Addendum #2 for
St. Joseph University Catholic Parish
Terre Haute, IN
Parish Hall
September 17, 2026

CHANGES TO THE PROJECT MANUAL

CHANGES TO THE DRAWINGS

DETAILED
GRADING PLAN
C301

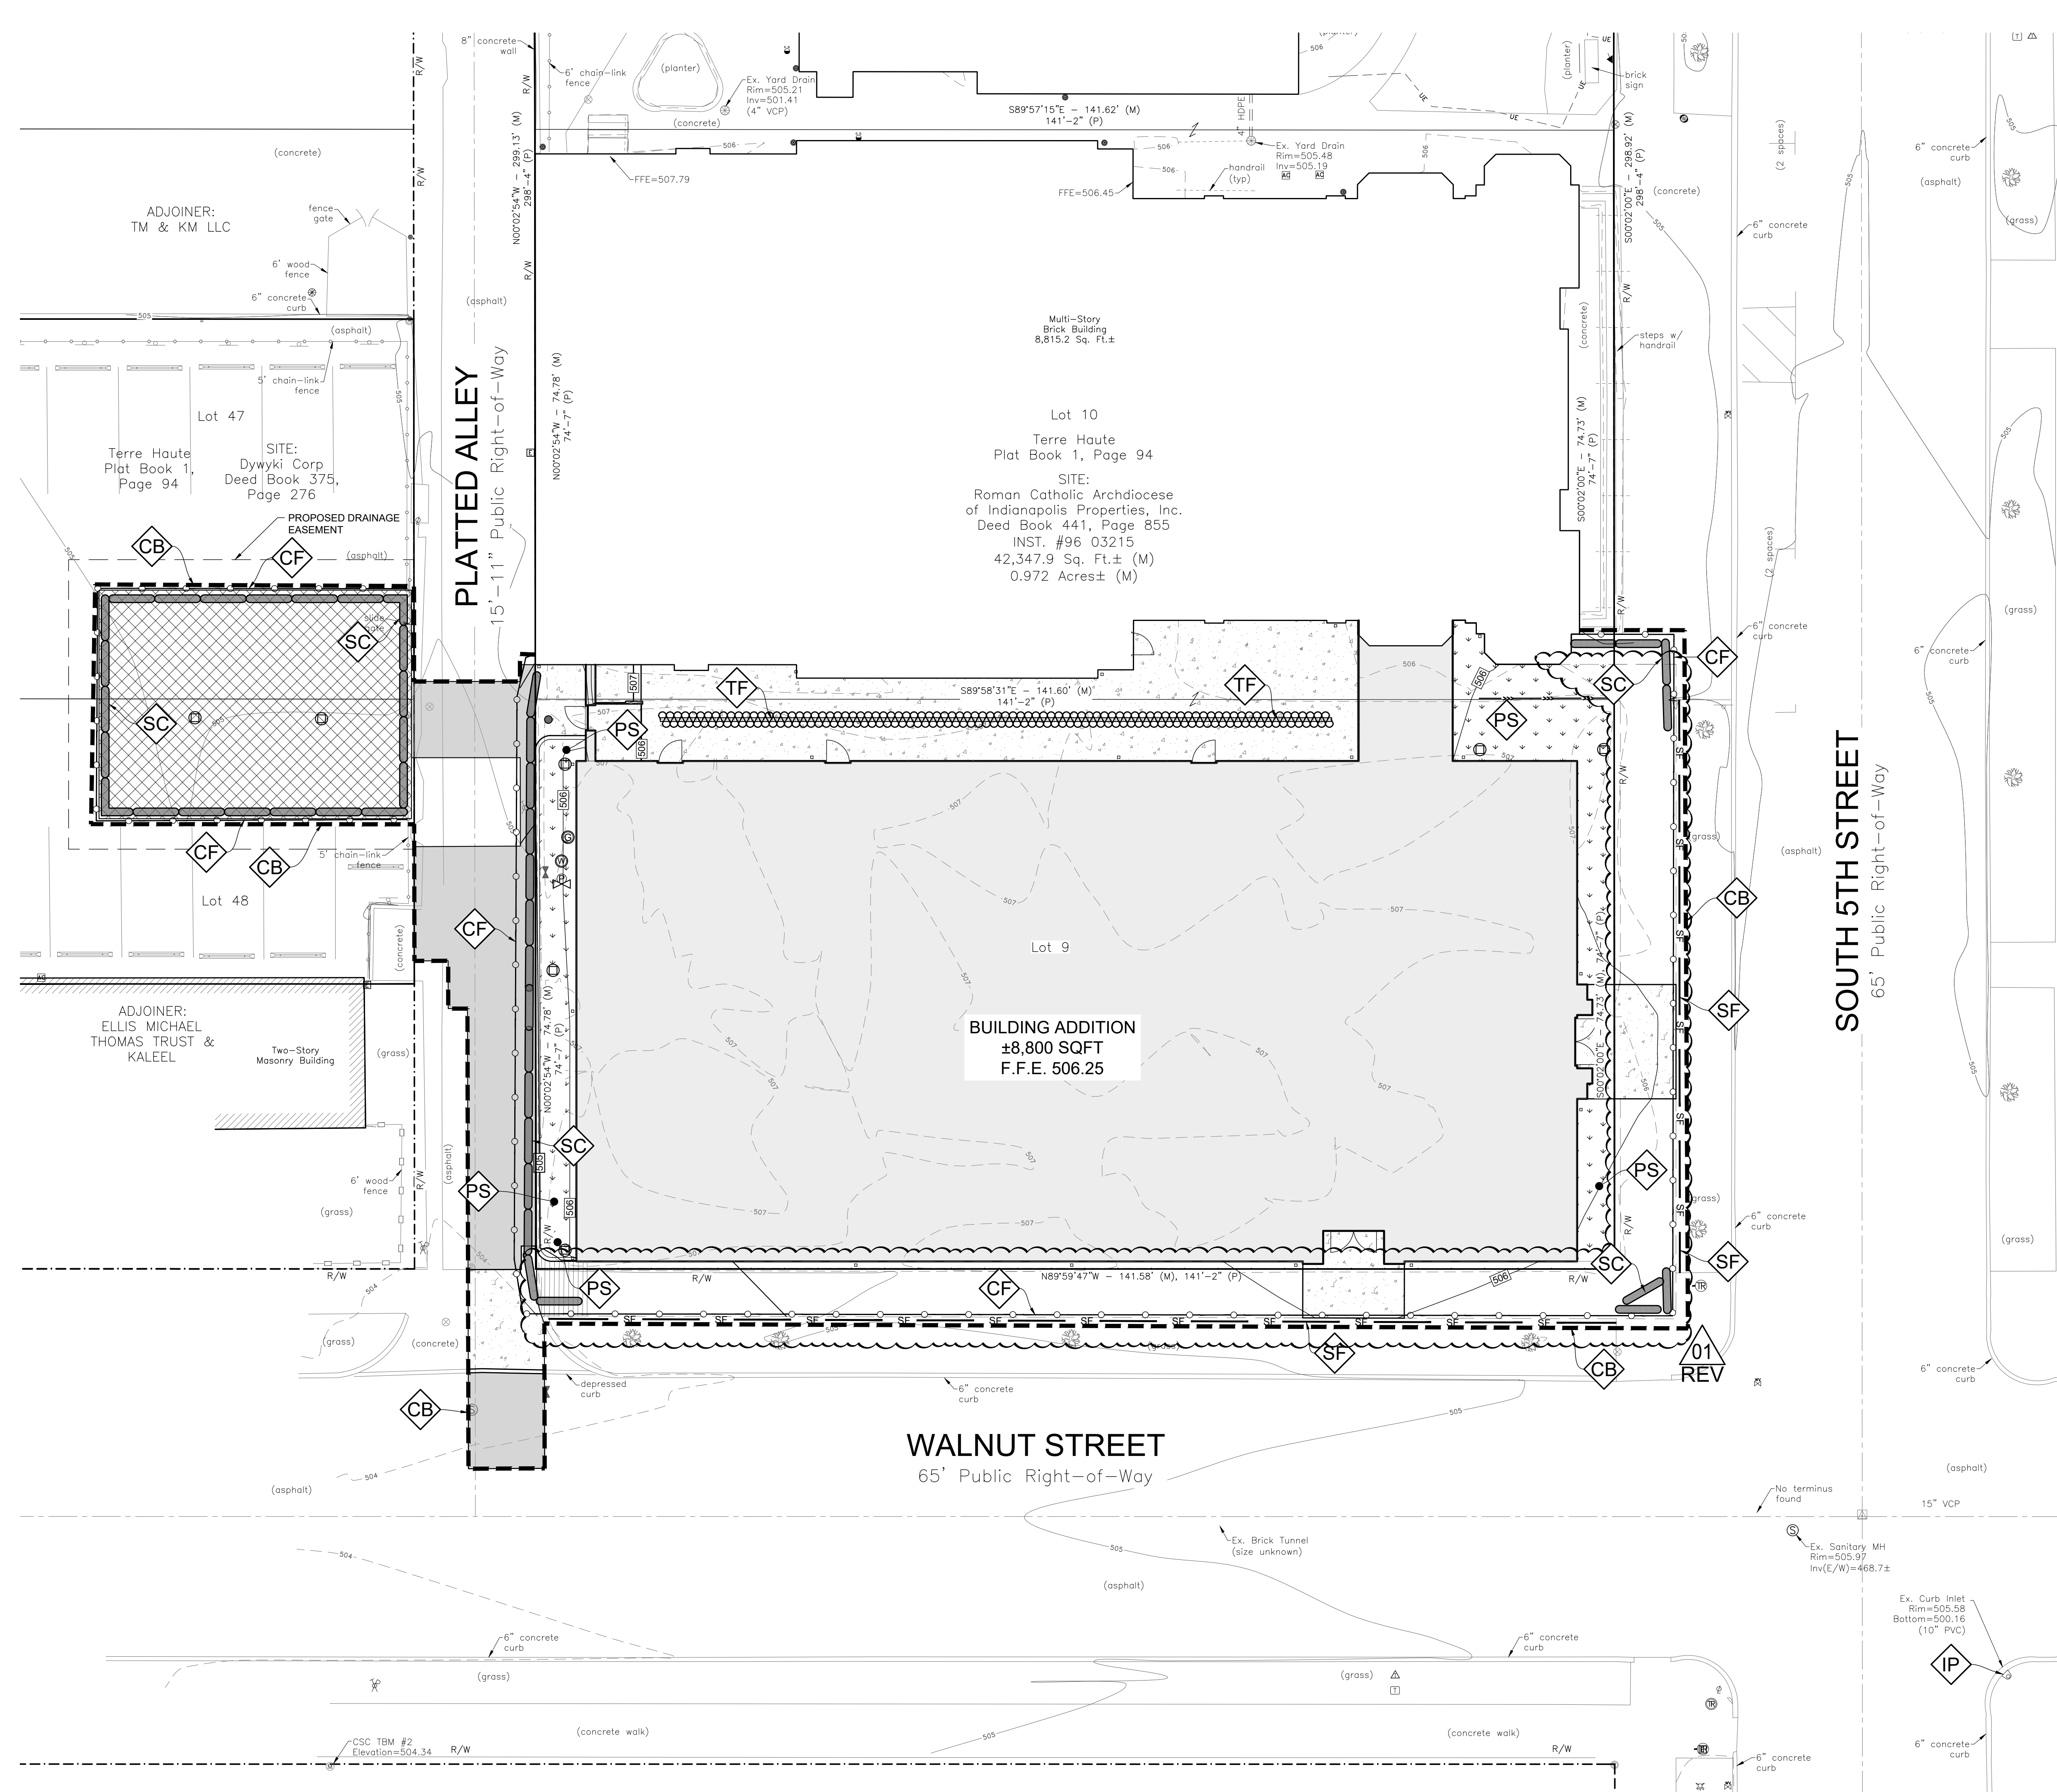
1. Step count and elevations updated between new and proposed buildings.
2. 'ADA Ramp Detail 02' removed from lower left.
3. Replace sheet in its entirety.

CONSTRUCTION
EROSION CONTROL PLAN

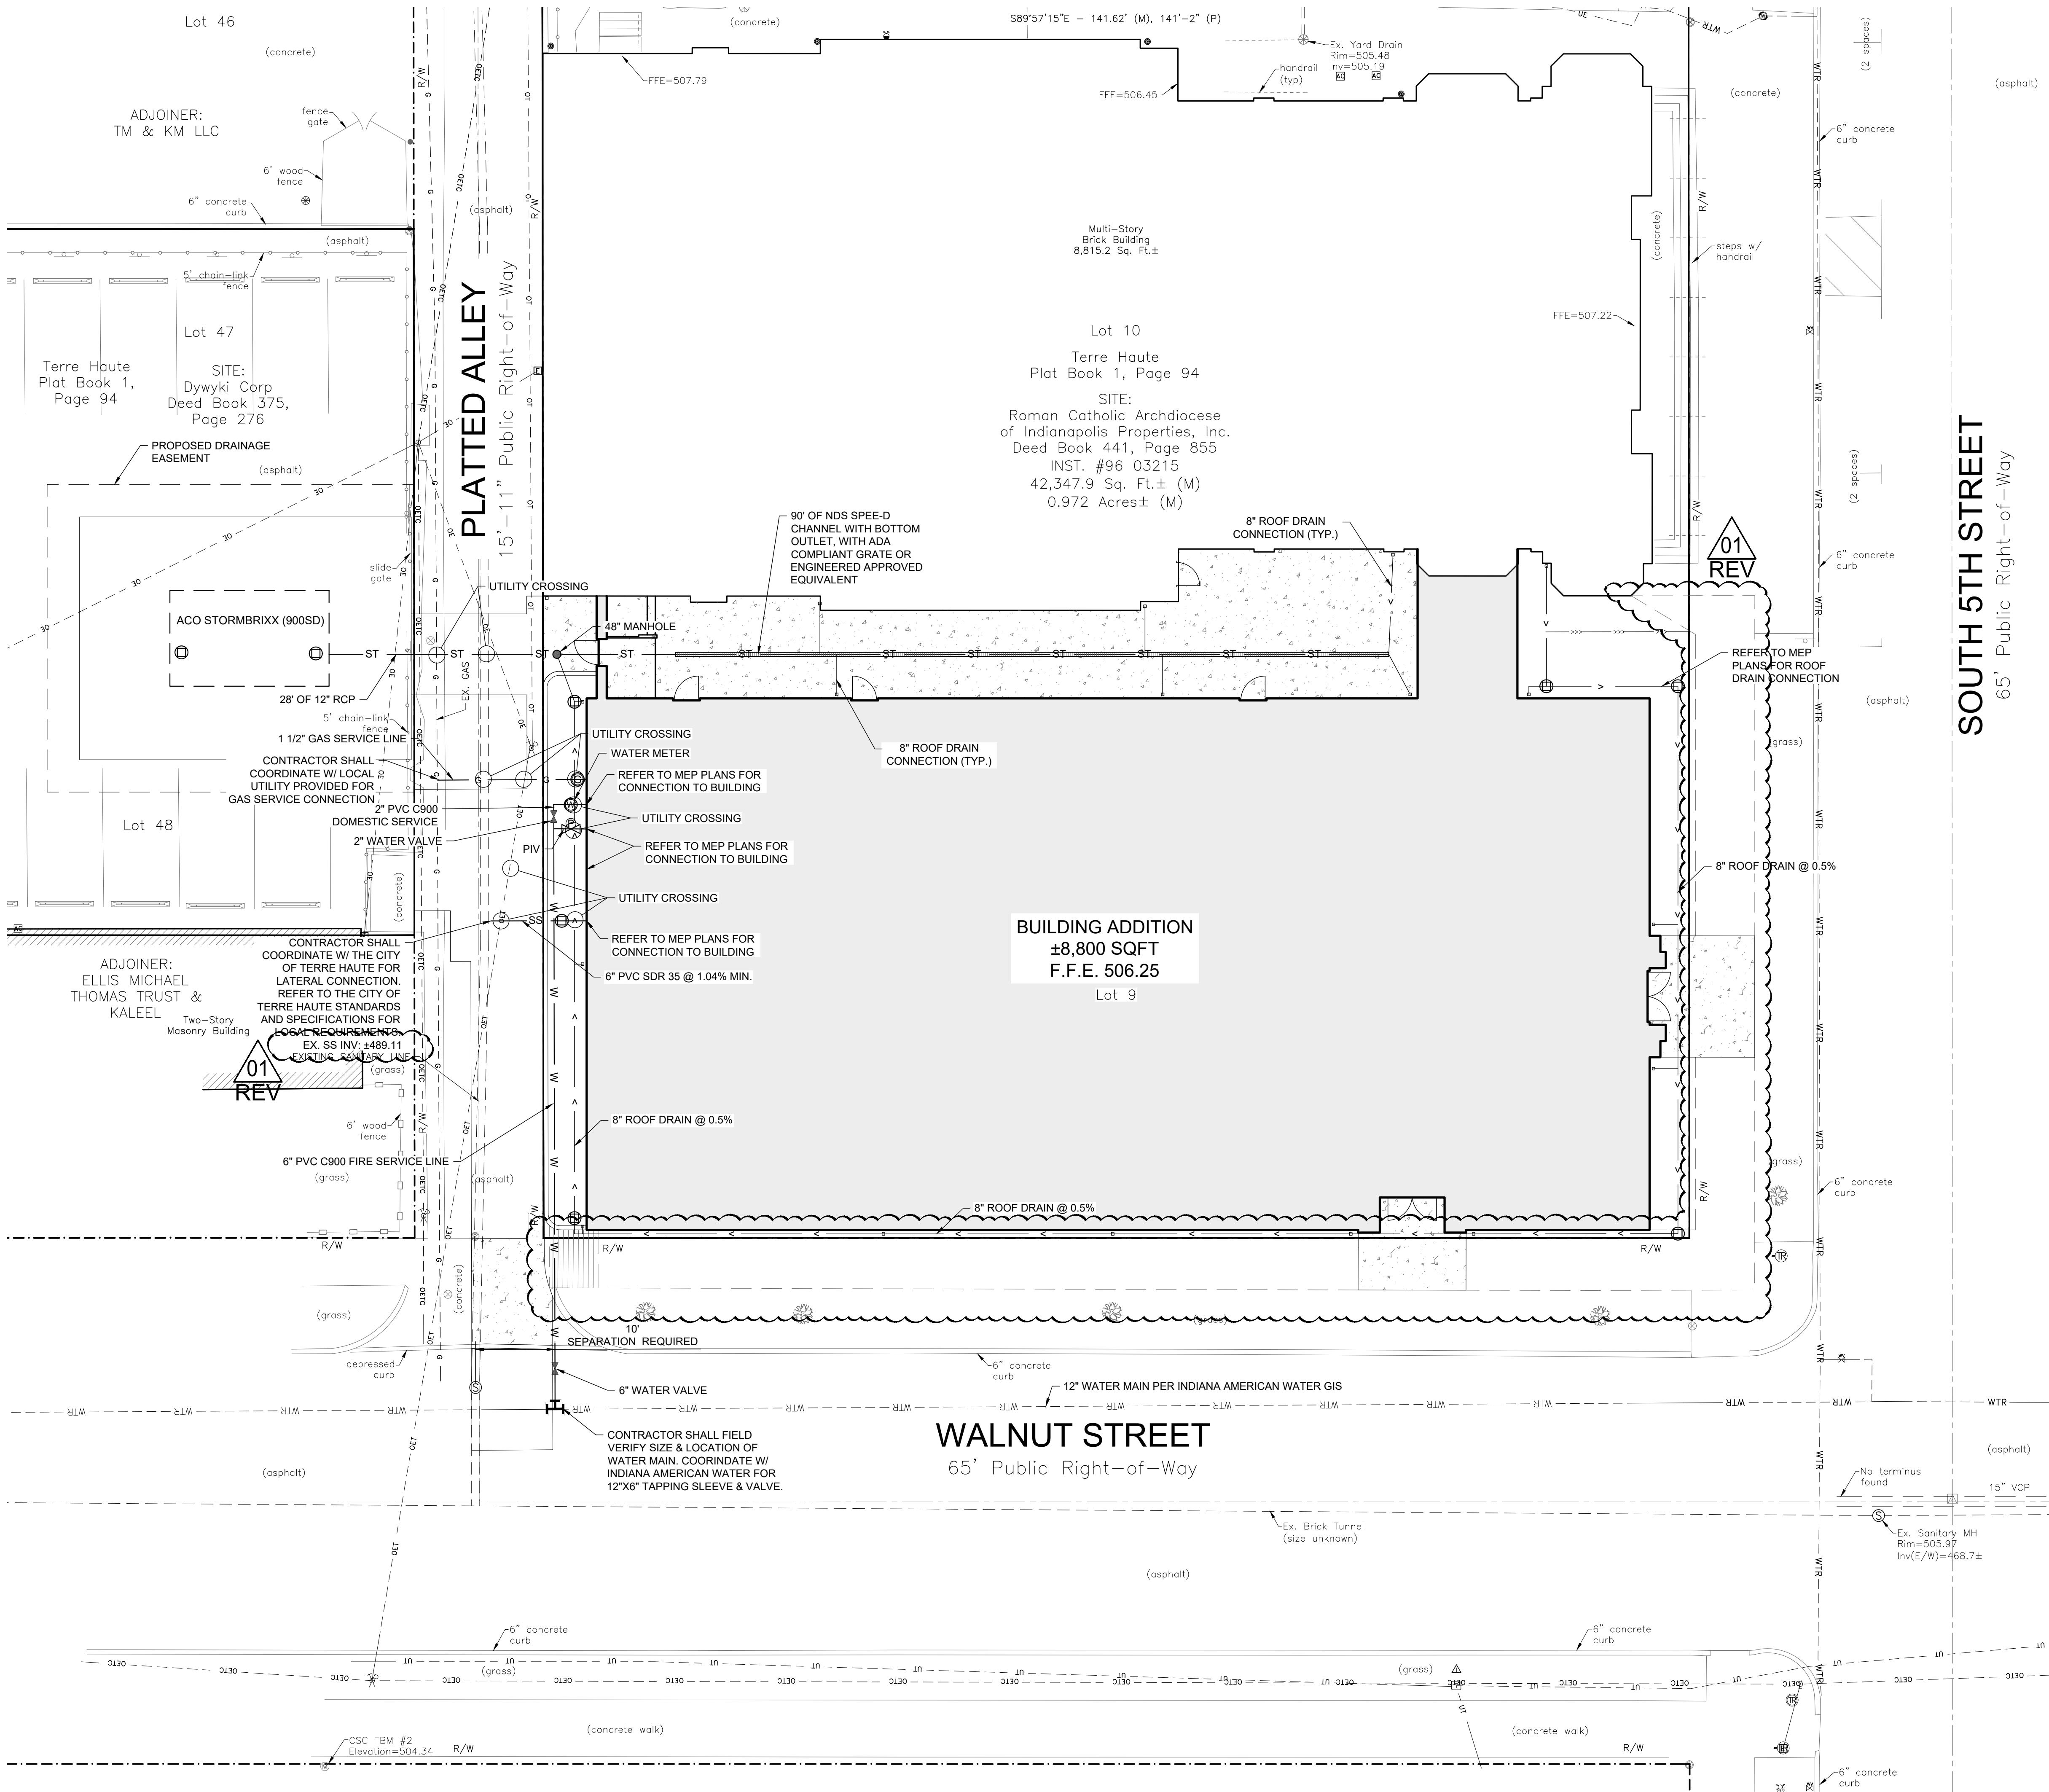
1. Proposed sidewalk along Walnut and South 5th Street has been removed except for pads at building access points. Replace sheet in its entirety.

WATER SERVICE BEDDING
NOT TO SCALE

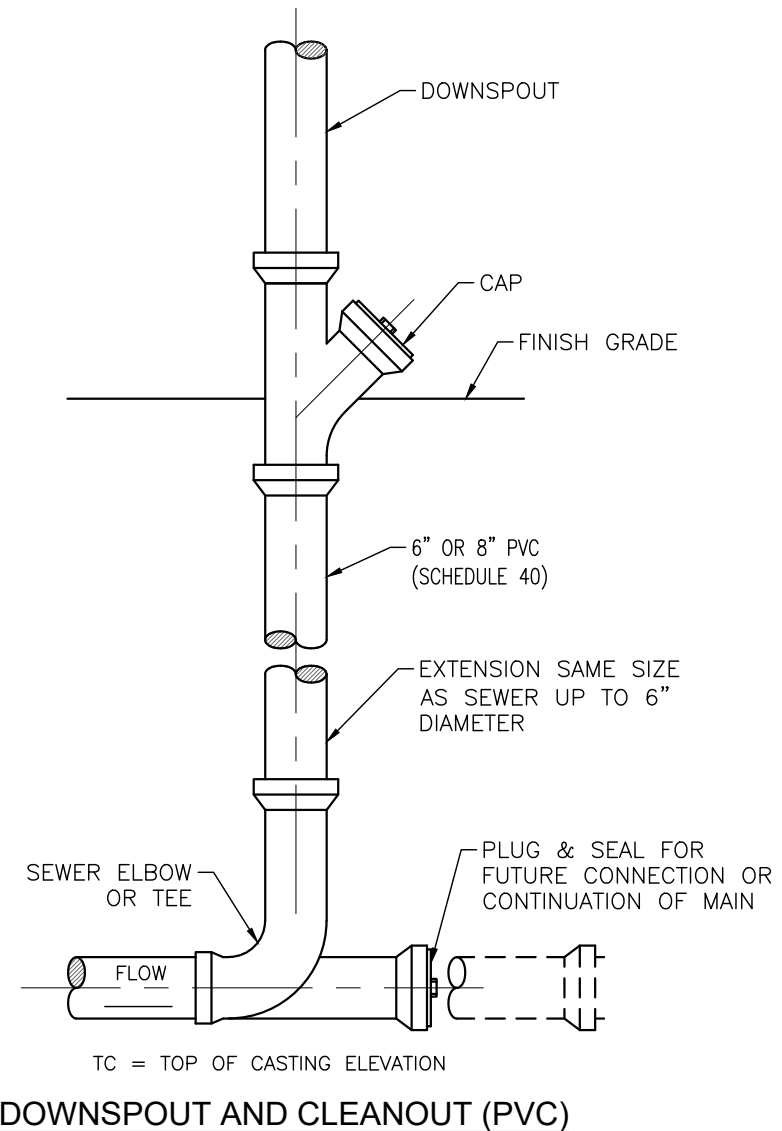
1. 'Water Service Bedding' detail added. Replace sheet in its entirety.
